COMMENT RESPONSE DOCUMENT

EASA PAD No.: 26-009

Published on 22 January 2026 and officially closed for comments on 19 February 2026

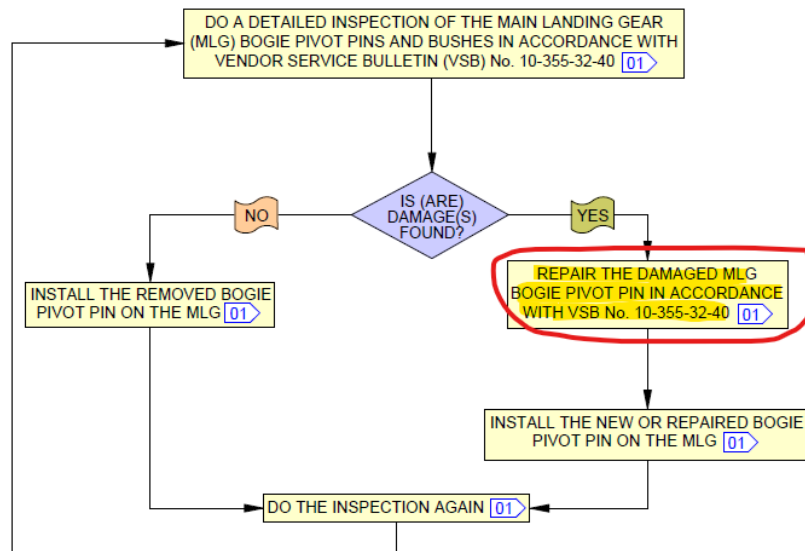
- a. The inspection and corrective action may also be accomplished in shop
- b. This RACT mentions that in case of findings, replacement of affected parts is required iaw the instructions of the ISB (Ref.3) which is solely for on-wing units.
- c. This RACT instructs that replacement of parts is required before next flight in case of findings. However, Ref.2 is not only for the inspection of the BPP (Steps 3.C.3 & 3.C.4) but also covers the inspection of Bogie Beam & Slider bushes (Steps 3.C.5), and as highlighted in item a above, can be accomplished in shop. Ref.2 instructs the replacement of BPP in case of findings related to the BPP (step 3.C.3) and to contact Safran Landing Systems in case of findings during inspection of Bogie Beam & Slider bushes.

- i. While information on different types of damage to BPP is available in Ref.2 (step 3.C.4), this information is not available for Bogie Beam & Slider bushes (Ref. 2 step 3.C.5). QTR believes that Safran Landing System shall also provide information on the type of damage that Bogie Beam & Slider bushes are susceptible to.

- ii. QTR note that Ref.2 guides for the replacement of the BPP iaw CMM in case of findings. Consequently, QTR propose that the VSB Ref.2 and CMM are also reflected in RACT 2 to cater for corrective actions in shop

- iii. QTR propose that the statement in Ref.1 is updated to also allow obtaining / following approved repairs from Safran Landing Systems in case of findings for compliance (in addition to existing requirement of part replacement in RACT 2). This will be consistent with Ref.2 and also helpful for compliance in shop.

- iv. In reference to the word “replace” in this RACT, QTR will appreciate clarification and guidance on the following case: Inspection is performed in shop during MLG Assembly shop visit and reveal findings on BPP. The same BPP is repaired and re-installed on the same MLG Assembly.

D. Comment not agreed. The ISB refers to the instructions of the VSB. Consequently, the operator shall refer to the VSB while complying with the required actions. The parts repaired in accordance with Airbus approved instructions are considered serviceable parts, as per the AD Definitions.

The AD raises requirement at aircraft level, so if an MLG assembly has an affected part installed and such part is found damaged, this MLG assembly can be reinstalled on an aeroplane only if the affected part meet the AD serviceable part definition.

No changes have been made to the Final AD in response to this comment.
